To	Gertjan Groen	Date	12 October 2015
Copies	Craig Leech	Reference number	
From	Christoph Gruenau	File reference	
Subject	Response to JLL DA review Issue 23: Tower A building maintenance, BMU and potential for falling debris

We have reviewed the Kerry Hill Architect's drawings of the Wanda One Sydney – Tower A, proposals SSD 2015_7101 (City Reference D/2015/1049) and amending DA 2015_882) in specific reference to “Issue 23: Tower A building maintenance, BMU and potential for falling debris” raised by JLL on behalf of Lend Lease Development Pty Ltd. The impact to the safety and security of the Jacksons on George premises is a valid one and needs to be addressed.

Figure 1: BMU drop zone and cradle drop position

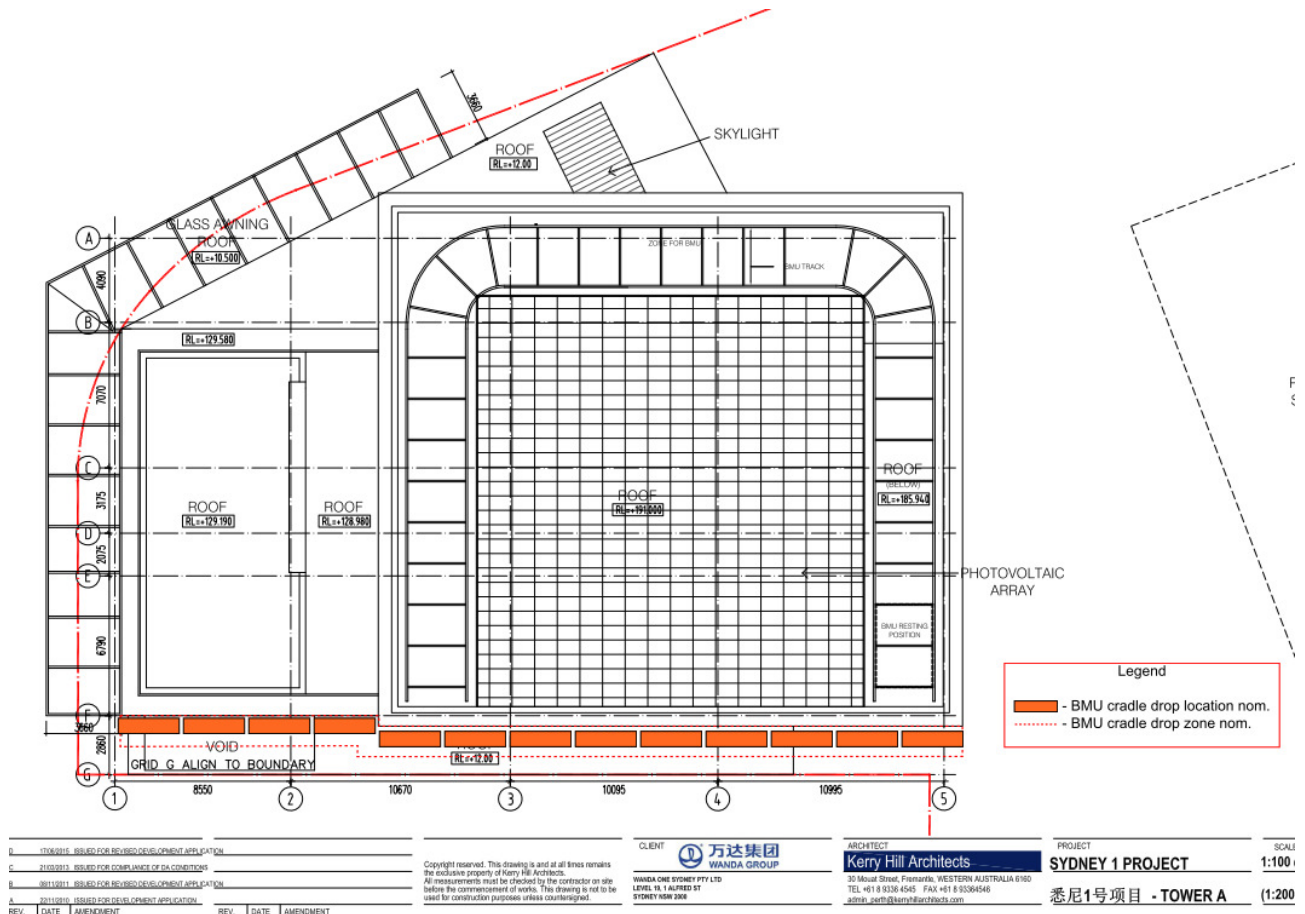
The preliminary design of the BMU system has the BMU cradle operating within 1500mm of the tower façade. The preliminary design of the system requires a BMU cradle of nominal dimensions: 3000mm plan width, 800mm plan depth and 1200mm height in elevation. For clarity the width of the cradle is measured parallel to the façade, and the depth of the cradle is measured perpendicular to the façade. Code requirements stipulate that the cradle must be within 600mm of the façade at all times, however typically it will be within 300mm. This cradle drop zone is well within the Sydney One boundary (see Figure 1). Figure 35 of the JLL submission incorrectly assumes that the spacing planning for the BMU resting position at the roof was indicative of the BMU cradle.

A typical sidewalk closure during a cleaning operation requires a 4000mm plan width for a distance of 2000mm from the building face. This allowance is entirely within the Sydney One property and thus the danger and inconvenience to the adjacent property is no worse than this public way.

1. We do not believe that this situation presents an abnormal risk nor special considerations beyond that addressed in the existing design regulations;
2. No comment provided.
3. We believe that detailed design of the BMU can feasibly ensure that the BMU does not protrude past the property line and thus approval from the adjacent landowner, as suggested, would not normally be required; and
4. The risk mitigation methods described above reasonably address this concern.
